ADDENDUM

Date Issued:	July 3, 2025
Project:	North Pointe Medical Park Tooele Pediatric Clinic- Rebid Set Building 'B' - Level 2 Suite #B202 & 204 2371 North 400 East, Tooele UT 84074
Addendum Number:	3

Electrical Addendum #3

Date: July 2, 2025
To: Sourabh Sinha
Company: NJRA Architects
Job: Northpointe Medical - Tooele
Building B - Pediatric Clinic
Job No: 250096
Cc:

A121

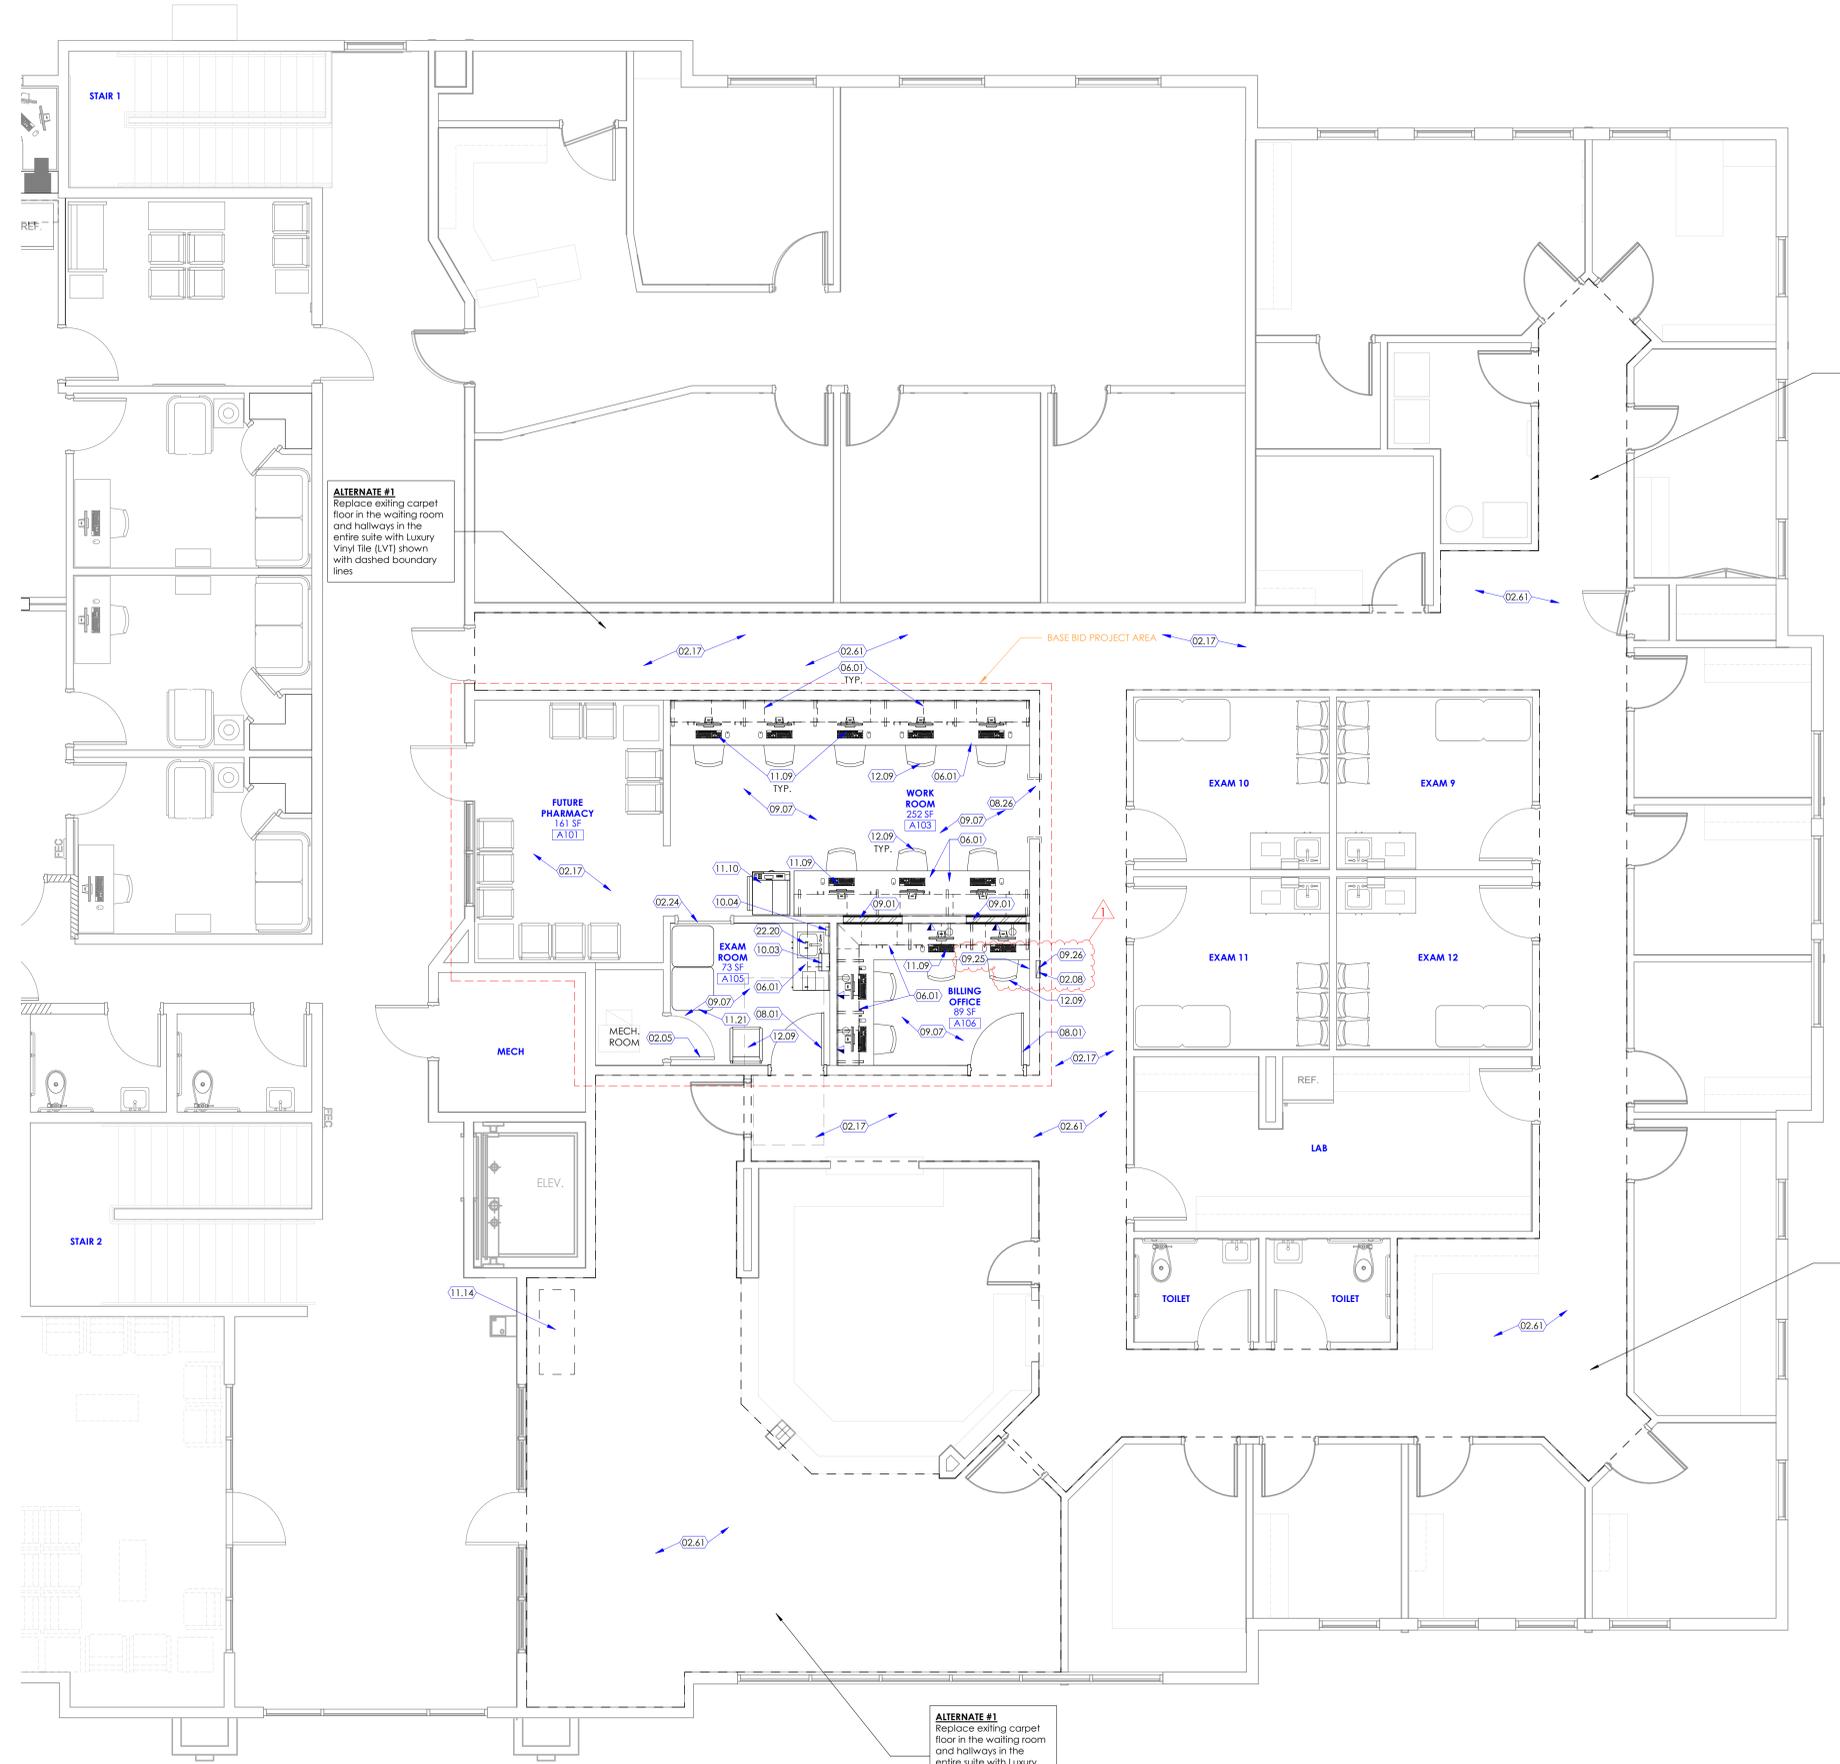
Item Number	General Items Description
1	As indicated in Addendum #2- All bids shall need to be Emailed to Sourabh Sinha with NJRA Architects at sousin@njraarchitects.com by Wednesday July 9, 2025- 2:00 p.m.
2	At the request of the Owner, We have revised the drawings regarding the electrical panel in the storage room. See attached architectural and electrical addendum #3 memo and revised drawings from NJRA & Spectrum Engineers.

- 02.07 EXISTING SHELVES INDICATED WITH DASHED LINE TO BE REMOVED.
- 02.08 EXISTING ELECTRICAL PANEL TO BE REMOVED. FLIPPED AND REINSTALLED ON THE HALLWAY SIDE. SEE ELECTRICAL DRAWINGS FOR MORE INFORMATION.

A123

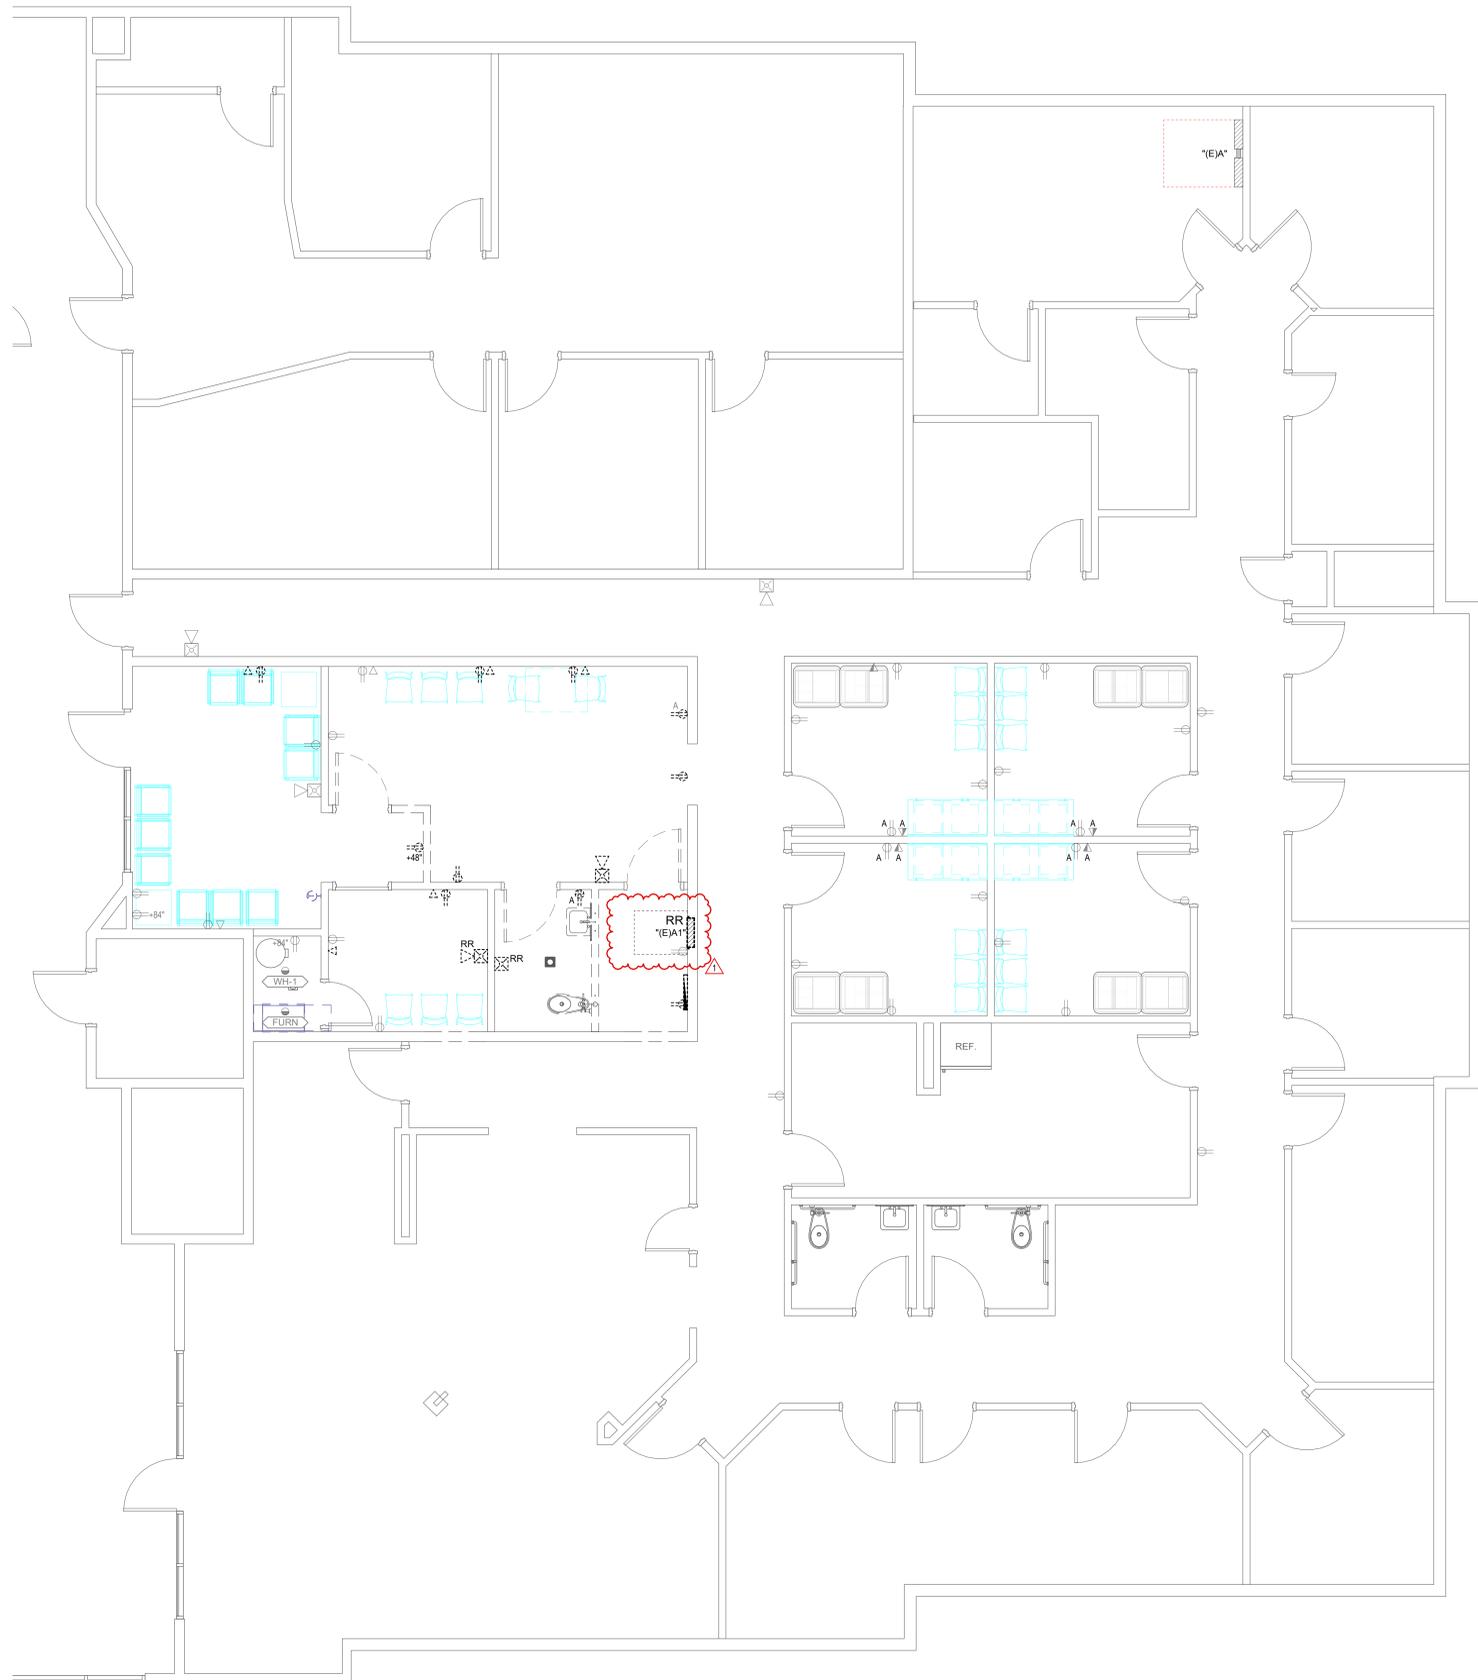
- 02.05 DOOR, EXISTING TO REMAIN. PROTECT DOOR FROM DAMAGE DURING CONSTRUCTION.
- 02.08 EXISTING ELECTRICAL PANEL TO BE REMOVED, FLIPPED AND REINSTALLED ON THE HALLWAY SIDE. SEE ELECTRICAL DRAWINGS FOR MORE INFORMATION.

- 09.25 PATCH, FILL, REPAIR AND PAINT GYPSUM WALL AFTER REMOVAL OF ELECTRICAL PANEL FROM HERE. SEE ELECTRICAL DRAWINGS.
- 09.26 PATCH, REPAIR AND PAINT WALL AFTER INSTALLATION OF RELOCATED ELECTRICAL PANEL HERE. SEE ELECTRICAL DRAWINGS.

LEVEL 2
ELECTRICAL
DEMOLITION
PLAN
ED101

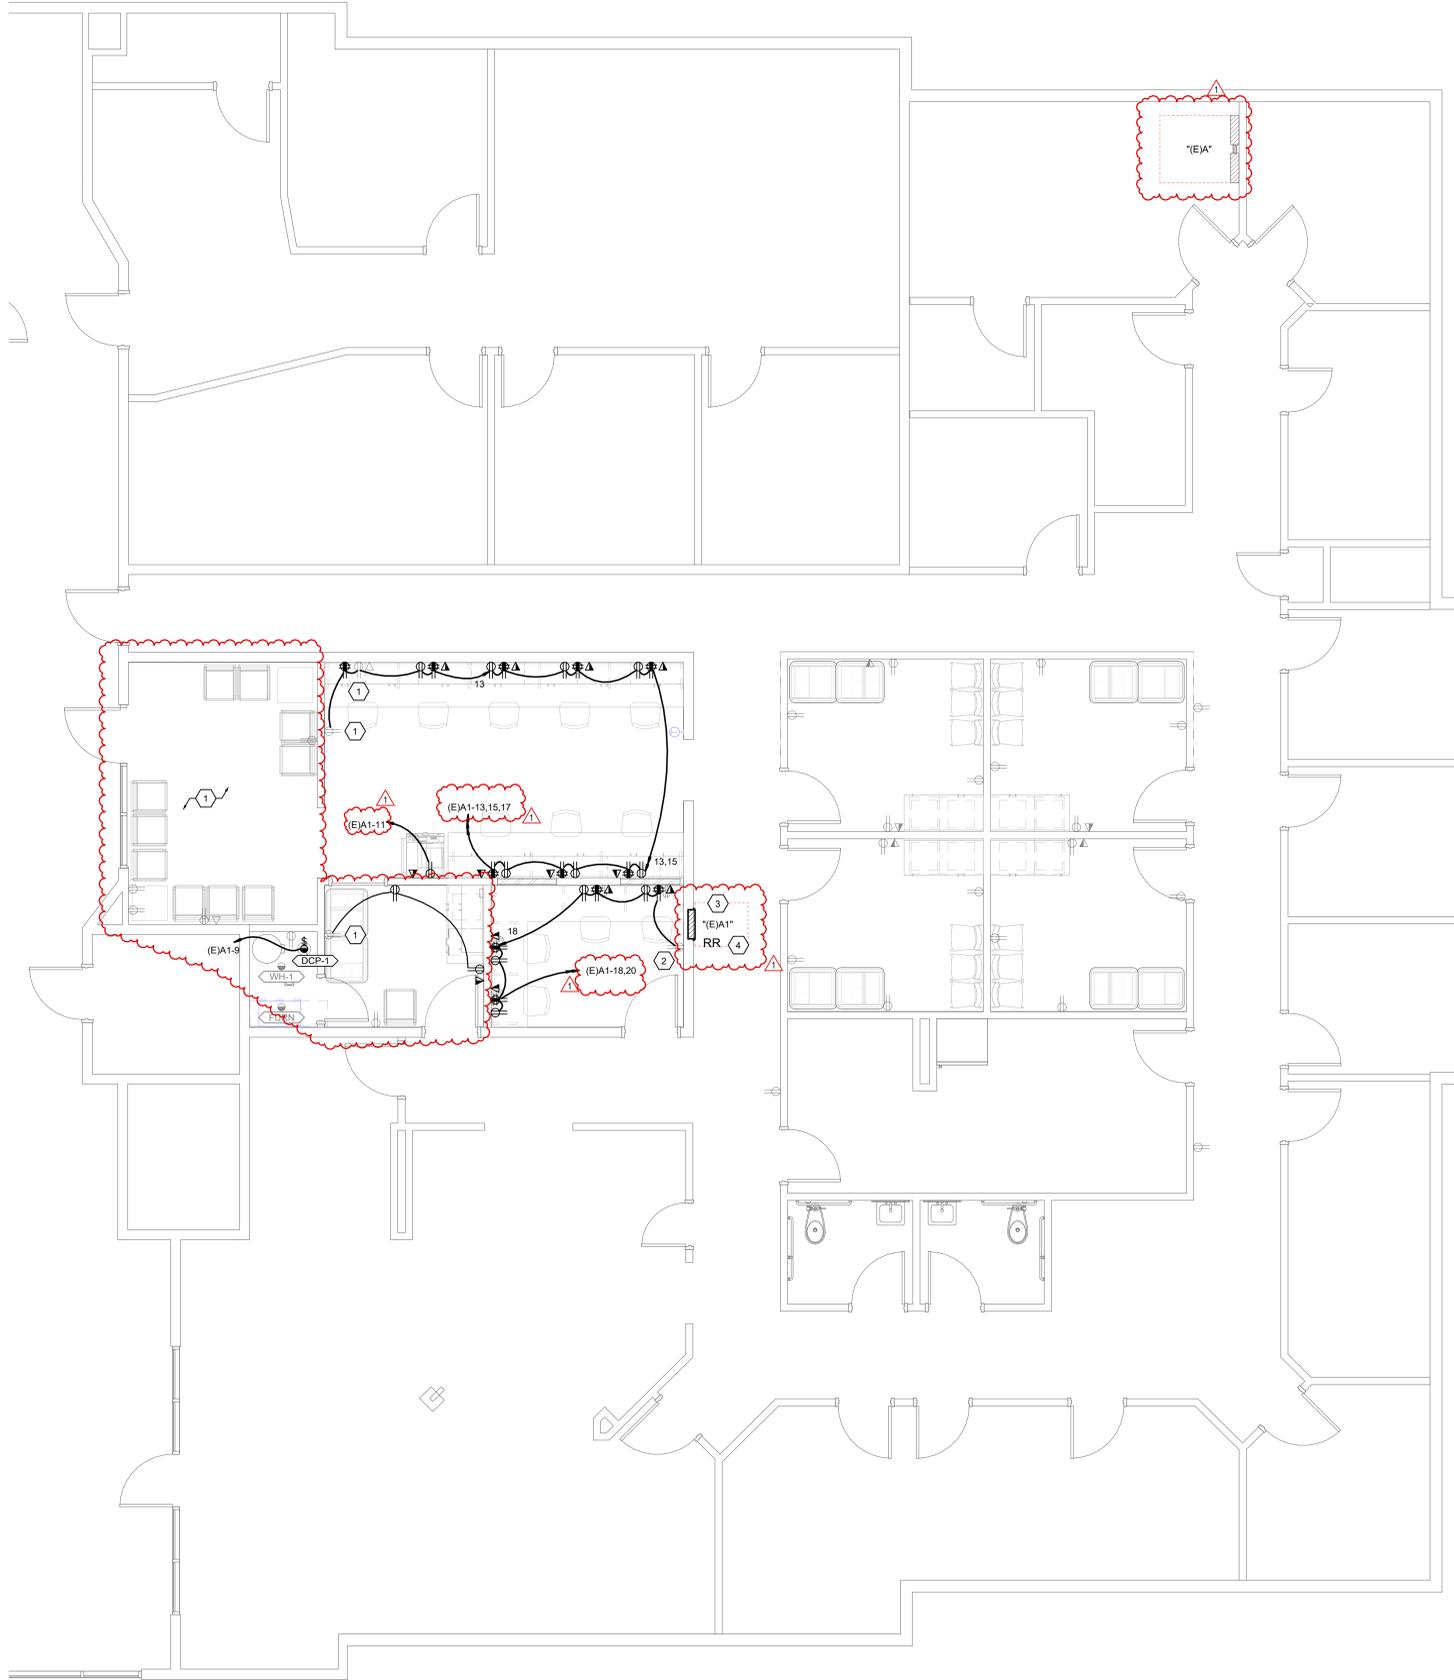
1. ED101 – Level 2 Electrical Demolition Plan
 - a. Changed panel from being demolished to be relocated.
2. EP101 – Level 2 Power Plan
 - a. Revised Circuiting.
 - b. Showed existing panel being relocated to corridor.
3. EP601 – One-Line Diagram
 - a. Updated one-lines to show relocated panel.
 - b. Updated panel schedules.
4. EL101 – Level 2 Lighting Plan
 - a. Updated circuiting.

EP101

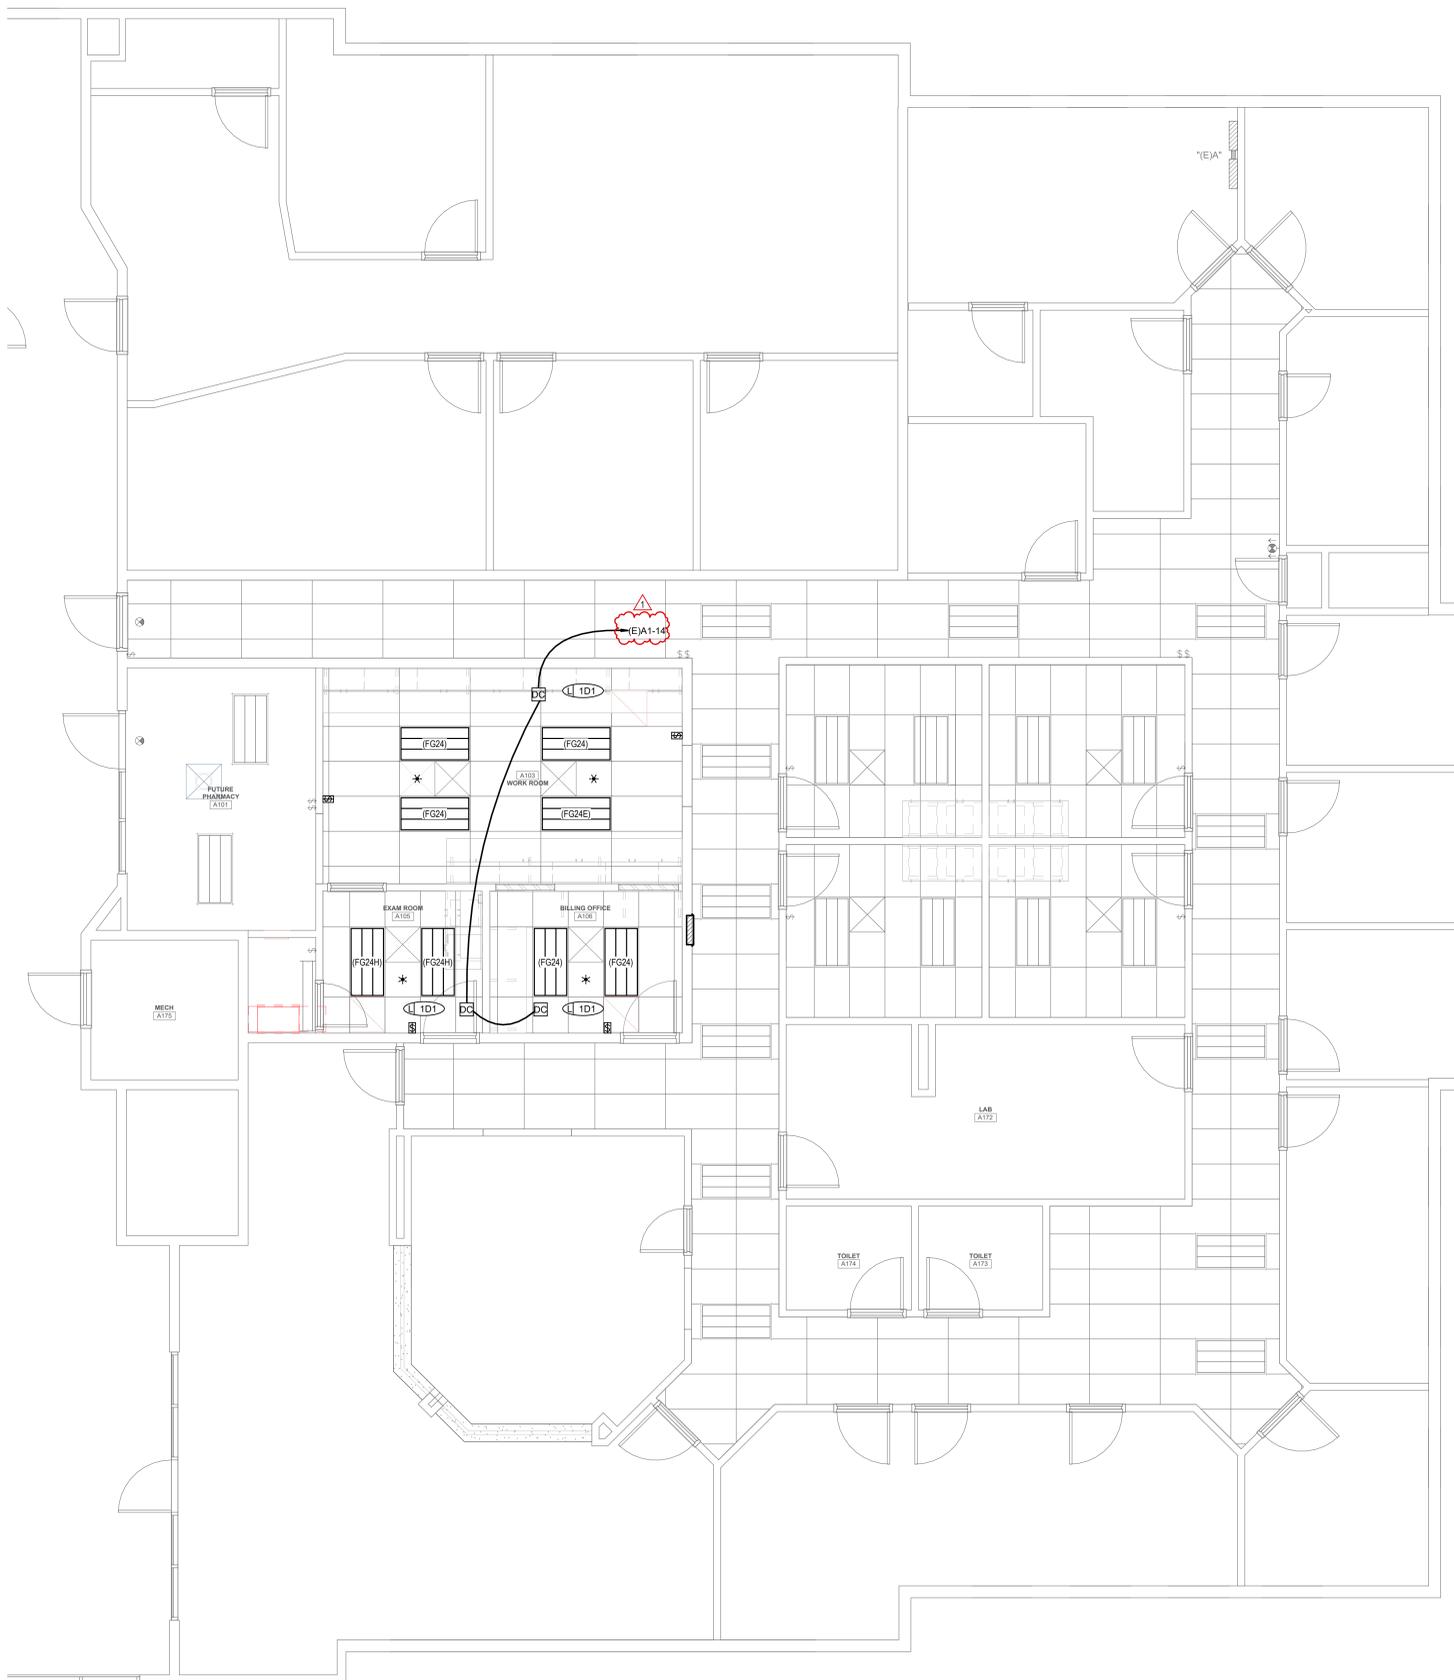
- EXISTING PANEL TO BE RELOCATED TO FACE THE CORRIDOR.
-
